ADDENDUM NO. 01

BCDM Architects
1015 North 98th Street, Suite 300
Omaha, Nebraska 68114

November 30, 2023

Arnold Elementary – Addition & Renovation
5000 Mike Scholl Street
Lincoln, NE 68524
&
Huntington Elementary Renovation
2900 North 46th Street
Lincoln, NE 68504
BCDM Project No. 5370-01

E2-1

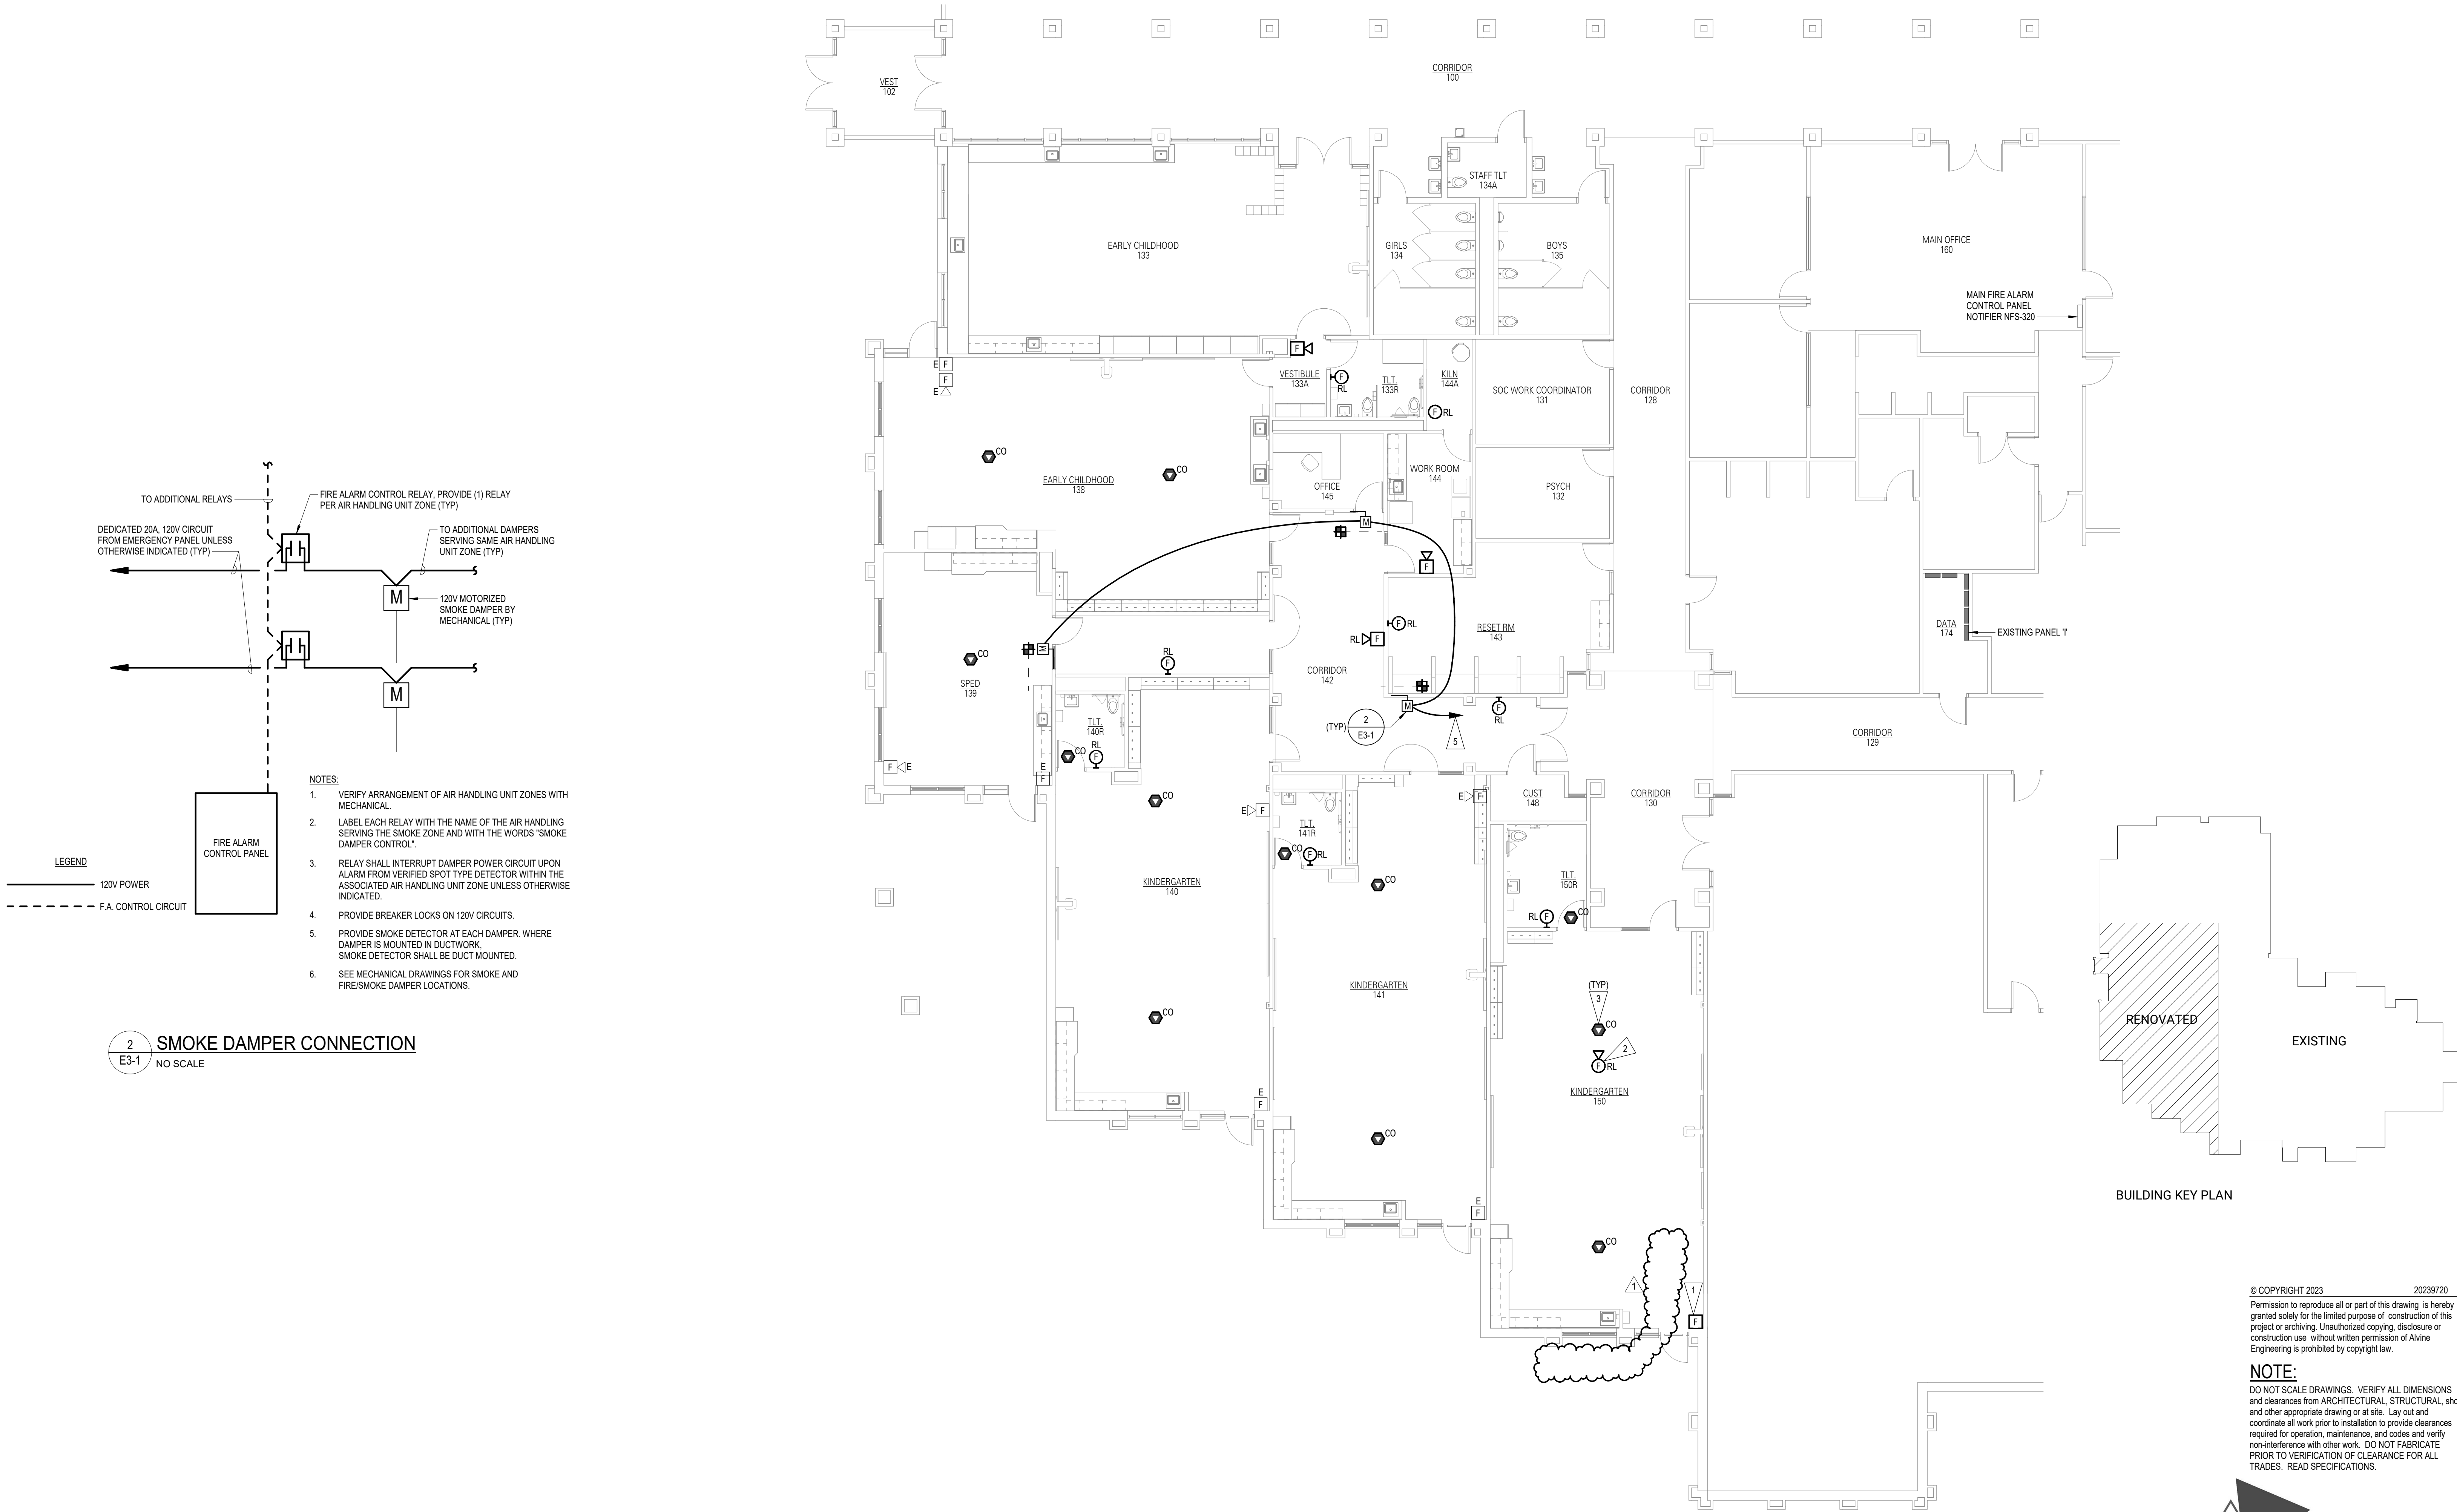
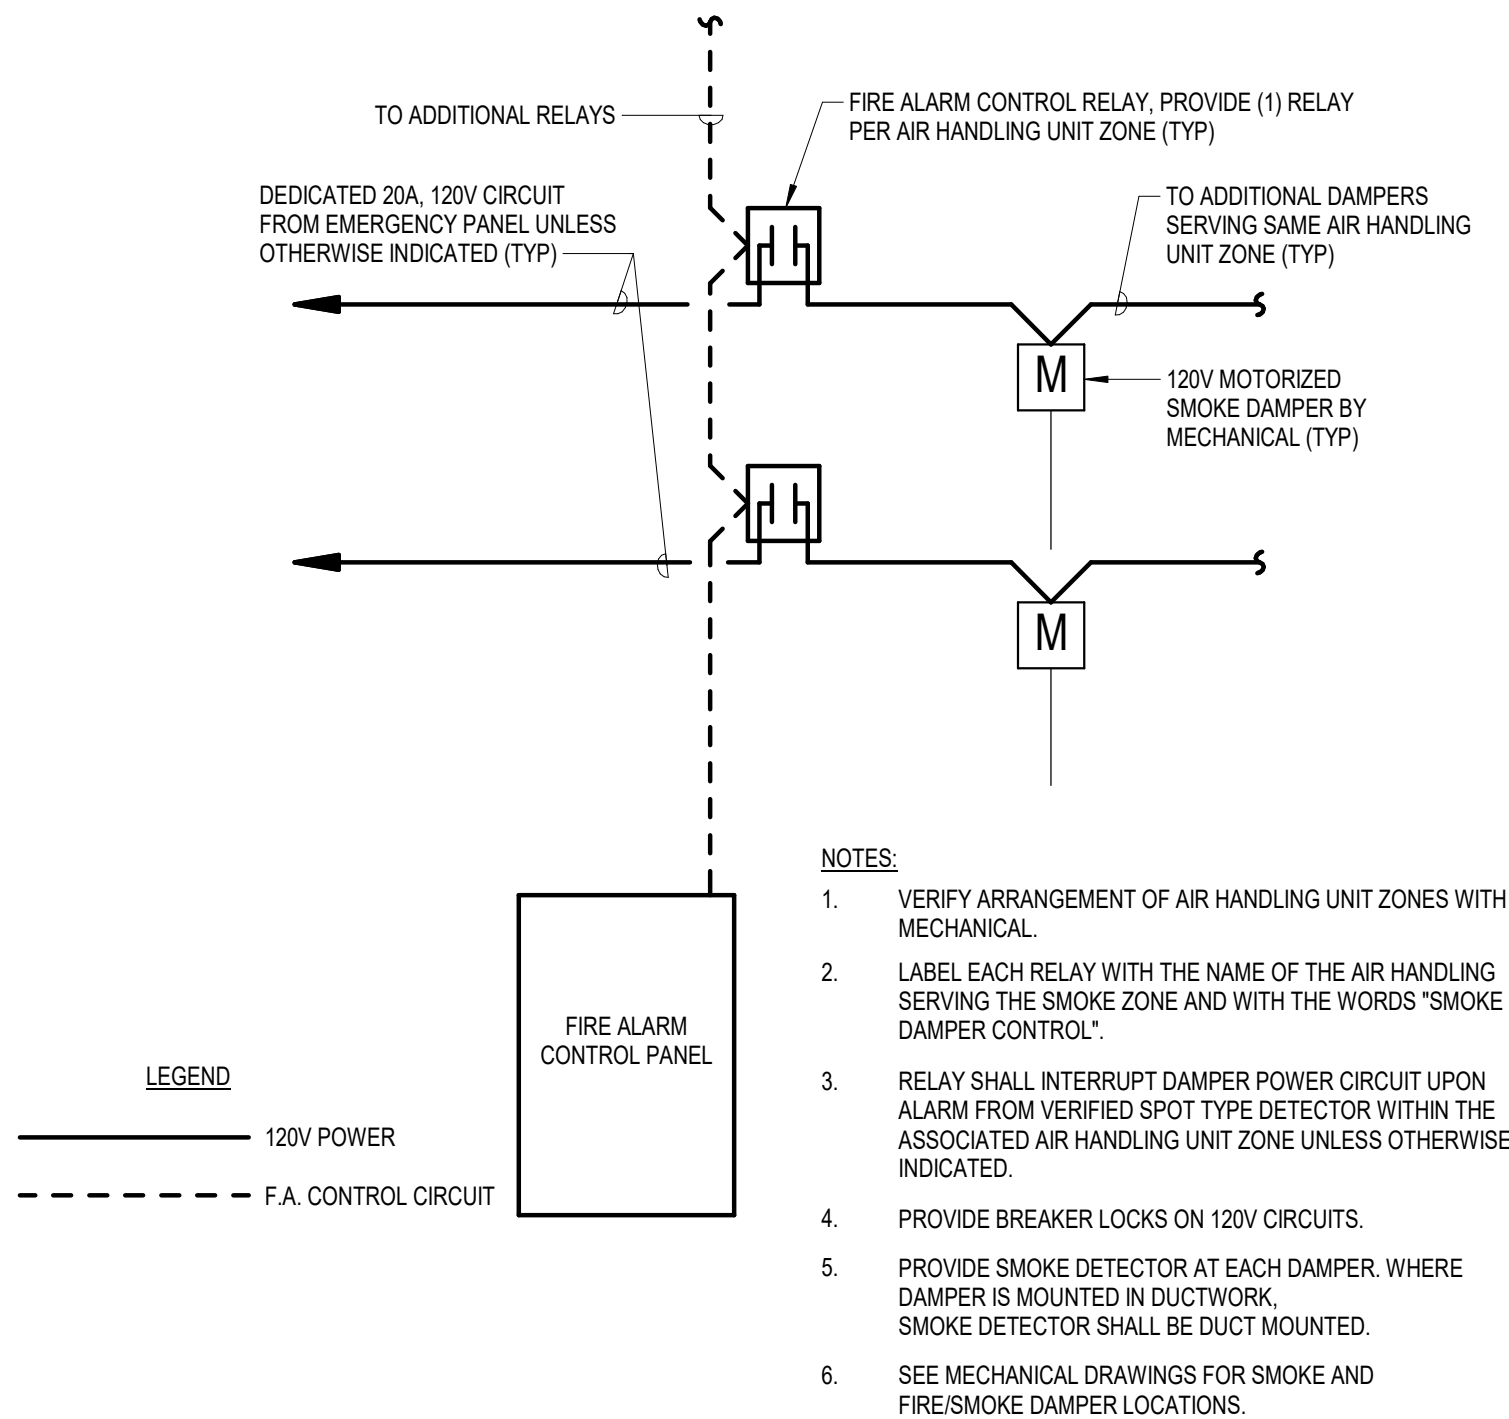
1ED3. Sheet E2-1 – First Floor Plan – Power – Mech/Elect Coordination Schedule

1. Add EF-8 on the roof above Office 145.
2. Work Room 144: Modify flag note on homerun from clothes washer to be 12.
3. Flag Notes: Delete Flag Note 9 and make 'Not Used.'
4. Flag Notes: Modify Note 11.
5. Delete electrical connection to door controller power supply near south exit door in Kindergarten 150.

1 FIRST FLOOR PLAN - TELECOMMUNICATIONS
1/8" = 1'-0" 0' 8' 16'

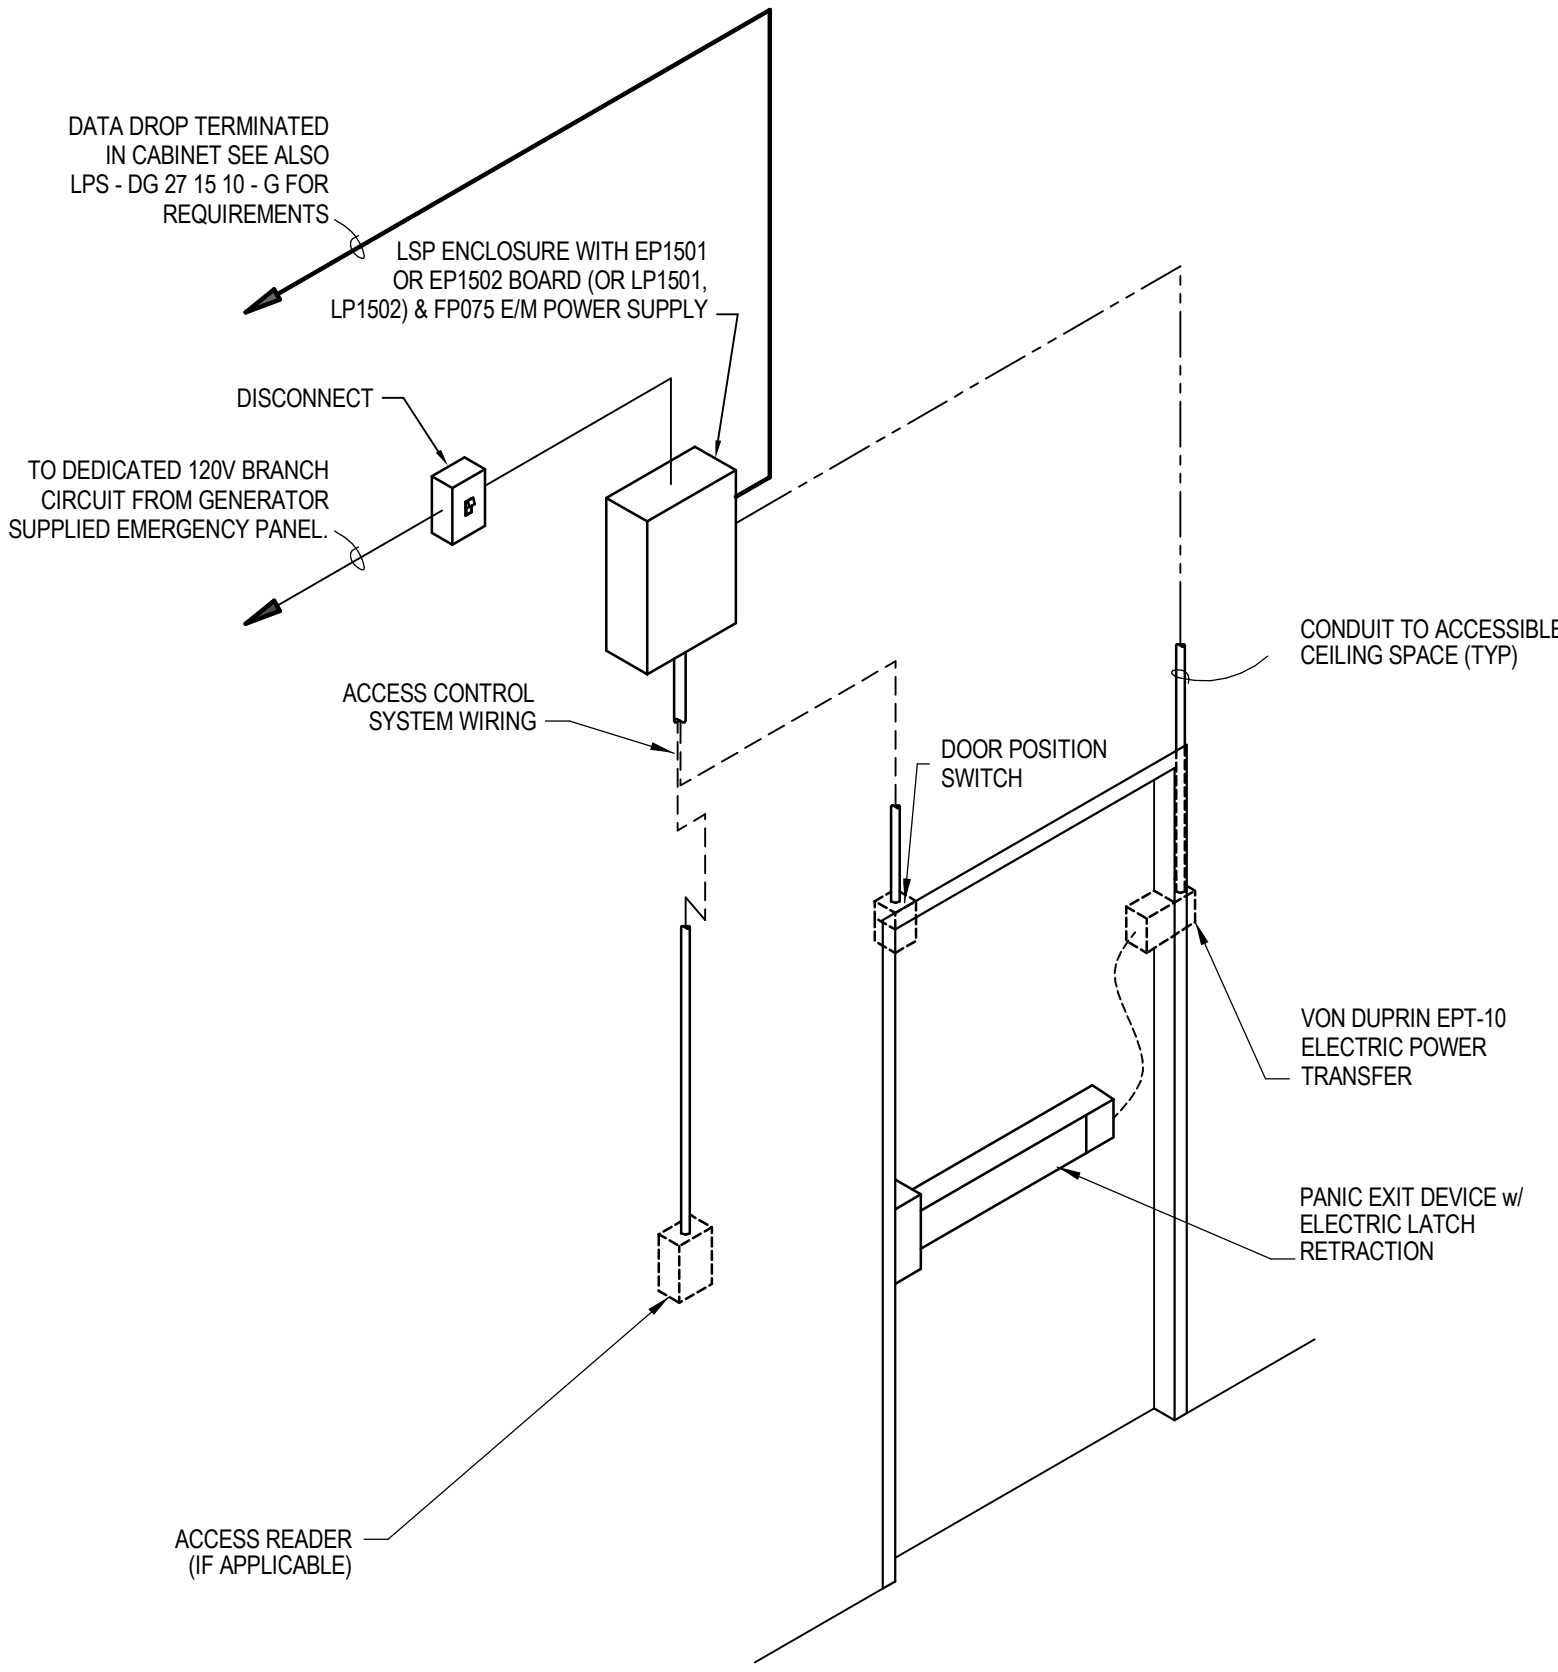
1TD1. Sheet T1-1 – First Floor Plan – Telecommunications

1. Add data to Room 150.
2. Add intercom speaker and call switch to Room 139.
3. Add Flag Notes 10 and 11.
4. See attached reissued sheet.
